Blackmoorfoot Road, Huddersfield
Proposed Internal Layout (Vistry Parcel)
Stage 1 Road Safety Audit

October 2025 (Initial Issue)

Blackmoorfoot Road, Huddersfield - Stage 1 Road Safety Audit Project No: 24040				
File reference	O:\Blackmoorfoot Road, Huddersfield (Vistry)\TEXT\REPORTS\251029 Blackmoorfoot Road, Huddersfield Stage 1 RSA Vistry Internals.docx			
Issue/revision	**Initial Issue**	**Revision 1**	**Revision 2**	**Revision 3**
Remarks	Final			
Date	29th October 2025			
Prepared by	M Whittaker			
Checked by	J Stackhouse			
Authorised by	M Whittaker

Table 2.1 Problem 1

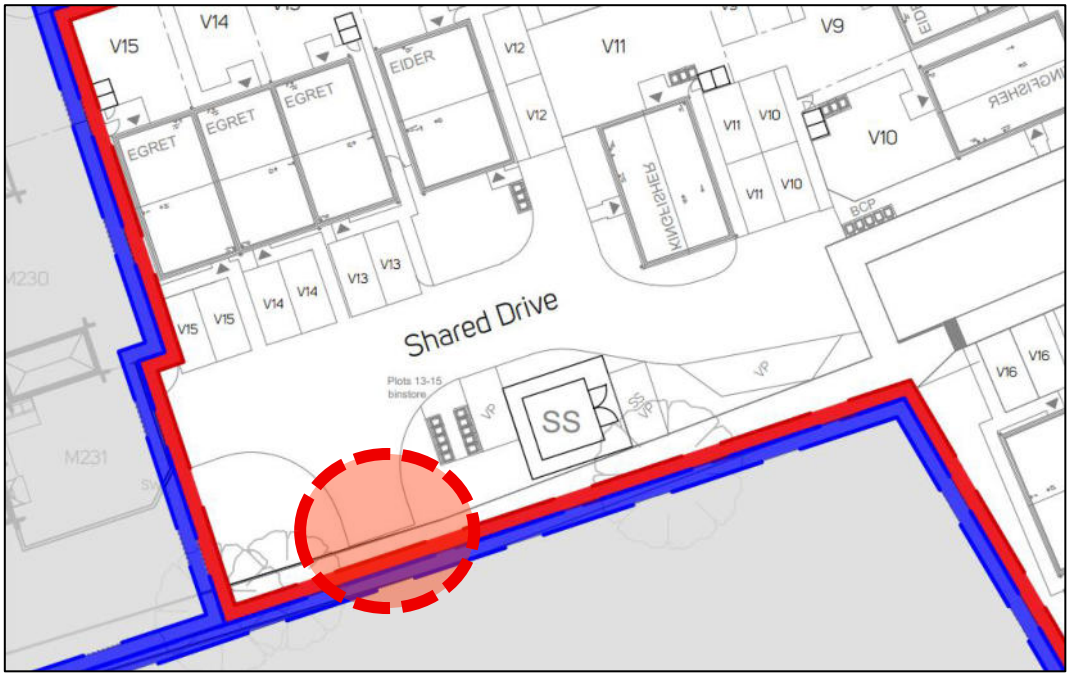
PROBLEM	
Location	Private drive serving plots 10-15 (at the head of Road V3).
Summary	The proximity of the turning head may conflict with users of the shared footway/cycleway.

A private drive serving plots 10-15 forms a turning facility immediately adjacent to the shared footway/cycleway connecting the Millers parcel with Road V3.

The proximity of the turning head to the path may result in larger vehicles reversing back onto or overhanging the shared footway/cycleway and increases the risk of a collision with a pedestrian or cyclist.

It is recommended that a suitable vehicle restraint barrier is provided between the shared footway/cycle and the turning head. Alternatively, it is recommended that the layout/design of the turning facility is amended to provide adequate separation.

Table 2.3 Problem 3

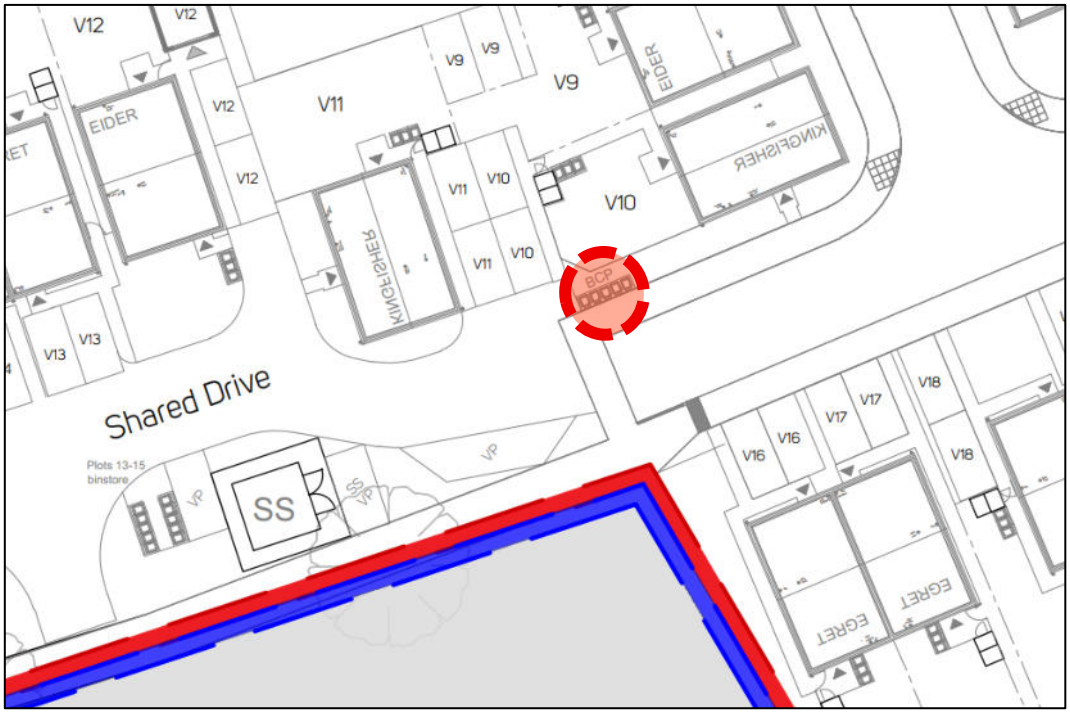
PROBLEM	
Location	Bin collection point adjacent to plot 10 (Road V3).
Summary	The bin collection point restricts visibility from the driveway.

A bin collection point is provided adjacent to plot 10, immediately to the east of the driveway. The bin collection point would be located within the pedestrian intervisibility splay. When occupied, the presence of the bins would likely block visibility between pedestrians on the footway and an emerging vehicle from the driveway, increasing the potential for a collision.

It is recommended that the bin collection point to the rear of the substation is enlarged to provide a single bin collection point for plots 10-15.

Table 2.4 Problem 4

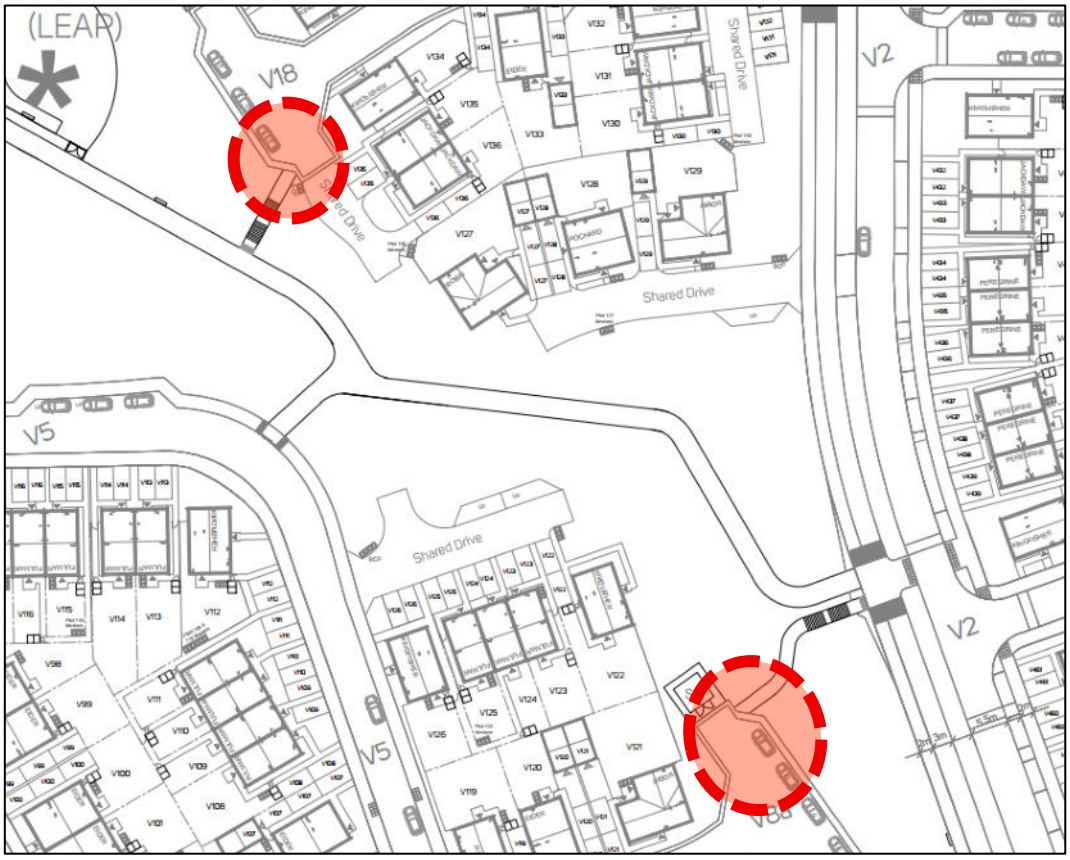
PROBLEM	
Location	Footpath connection opposite plots 121 and 134.
Summary	A pedestrian may be struck when emerging from the footpaths.

A pedestrian footpath is provided between road V2 and V8a (opposite plot 121) and between road V18 and the play area (opposite plot 134). Both footpaths emerge onto shared surfaces in close proximity to parking laybys and a bin collection point is also located immediately to the east of the connection onto road V18.

When occupied, the parking laybys (and bin collection point) are likely to restrict visibility to/from the footpath connection, particularly to smaller children. Although it is acknowledged that speeds will be very low, as reversing vehicles will be a common occurrence within the turning heads, there is a risk of a collision between a pedestrian and reversing vehicles.

It is recommended that pedestrian visibility splays are provided from the crossing position and the visitor parking bays and bin collection point are relocated accordingly.

Table 2.5 Problem 5

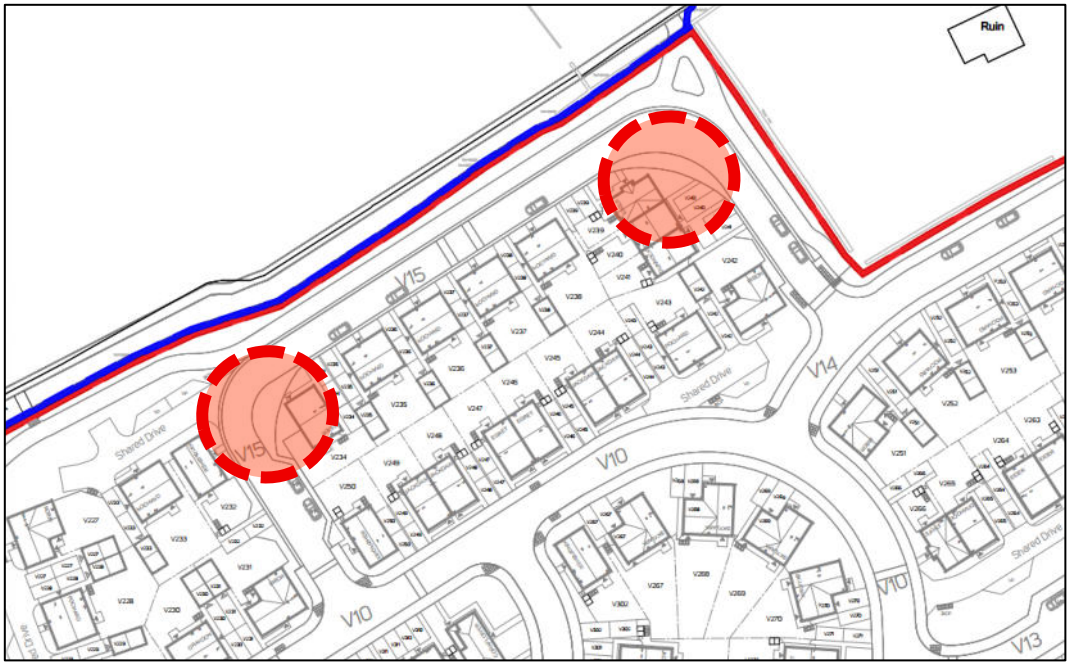
PROBLEM	
Location	Shared surface road V15 opposite plots 234 & 239.
Summary	Parking may occur on the widened margins.

Widened hard margins have been provided on the inside of the two ninety degree bends along road V15, adjacent to plots 234 and 239 in order to accommodate forward visibility.

Based on the drawings provided, this appears to be a widened hard margin. The widened area, may be used for parking, which would restrict forward visibility and potentially obstruct larger delivery or refuse vehicles, resulting in a potential vehicle-vehicle or vehicle-pedestrian collision.

It is recommended that measures are introduced in order to prevent parking within the forward visibility splays at the detailed design stage.

Table 2.6 Problem 6

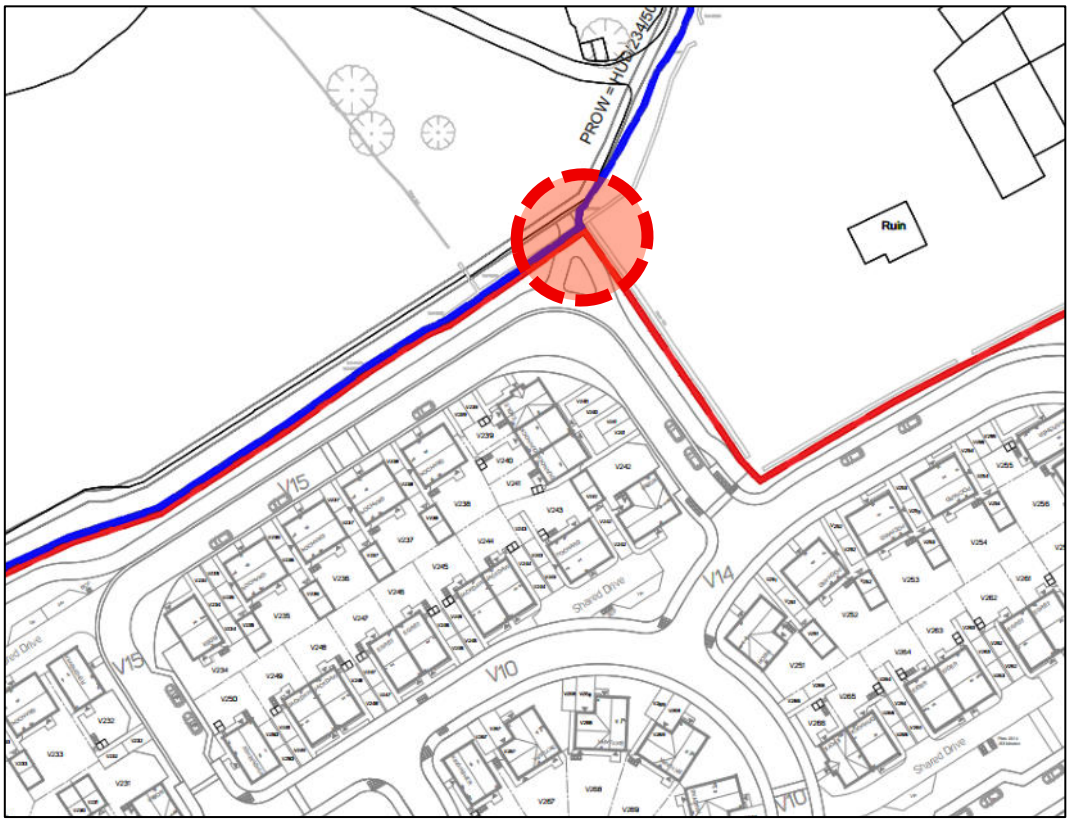
PROBLEM	
Location	Shared footway/cycleway connecting to PRoW HUD/234/50
Summary	Cyclists may use the footpath.

A shared footway/cycleway is provided at the northeastern corner of the development which connects to PRoW HUD/234/50, which is a footpath. No hazard warning paving has been provided, which may encourage cyclists to cycle along the footpath in conflict with pedestrians.

It is recommended that end of cycleway signage and hazard warning paving is provided at the detailed design stage.

Table 2.7 Problem 7

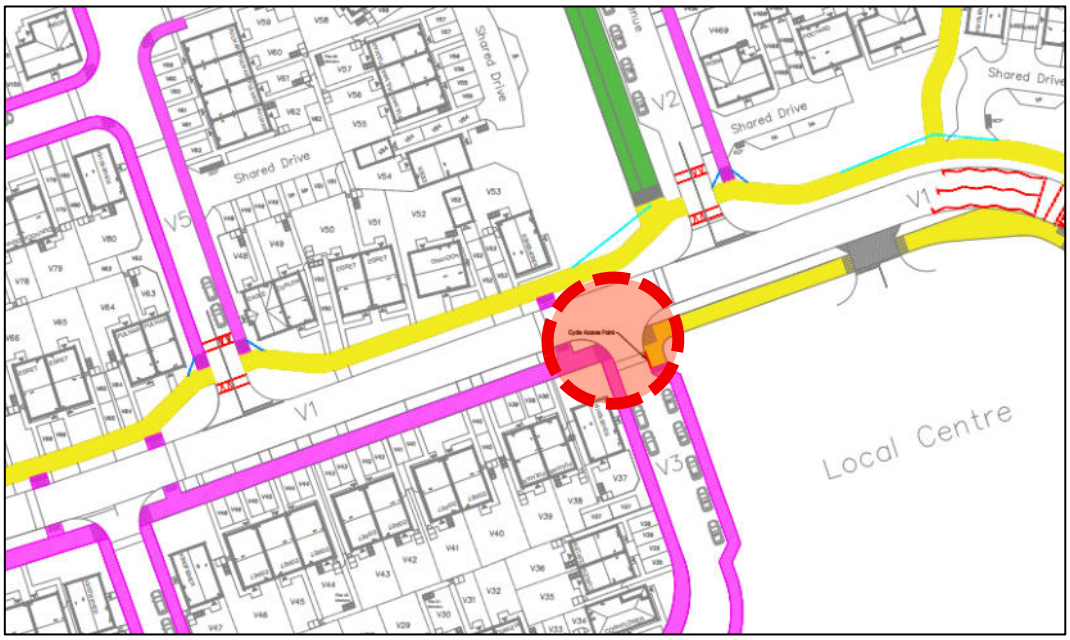
PROBLEM	
Location	Junction of road V1 and V3
Summary	Cyclists may continue along the footway.

A 3m wide shared footway/cycleway is provided along road V1 from its junction with Blackmoorfoot Road, around the local centre parcel and terminates where it meets road V3. Hazard paving is provided around the bend on the side road, however cyclists travelling westbound may be unaware that the facility has ended and could continue along the footway, which is laid out with the same 3m width. This could increase the risk of conflict between cyclists and pedestrians.

It is recommended that end of cycleway signage and hazard warning paving is provided in a suitable location to prevent use of the footway at the detailed design stage.
